TOWN OF PLAINFIELD PLAN COMMISSION REPORT

CASE NO.: [DP-23-081](#) (Incorrectly noticed as "PP-23-081")

REQUESTED ACTIONS: Development Plan Amendment - Architectural and Site Design Review for a façade renovation and 26,000 sq ft building expansion
Waivers – Building Materials
Development Incentives – Orientation of Loading Spaces

LOCATION: 2733 E. Main St.

Current Site

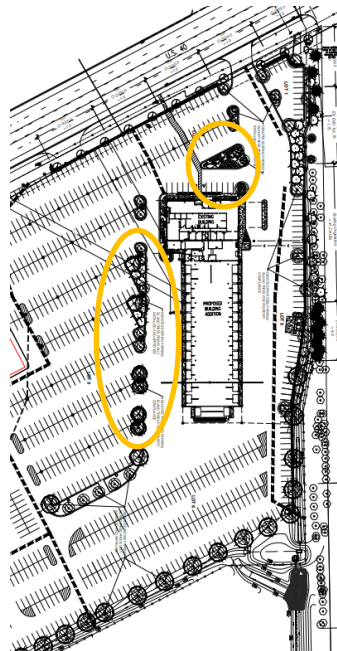
The site plan includes landscape island removal along the east side of the building as shown in yellow below. The landscape plan includes an expanded landscape island on the north side of the building. The petitioner has requested a Development Incentive to allow the overhead doors to face Main Street, and new and expanded islands have been added to provide screening.
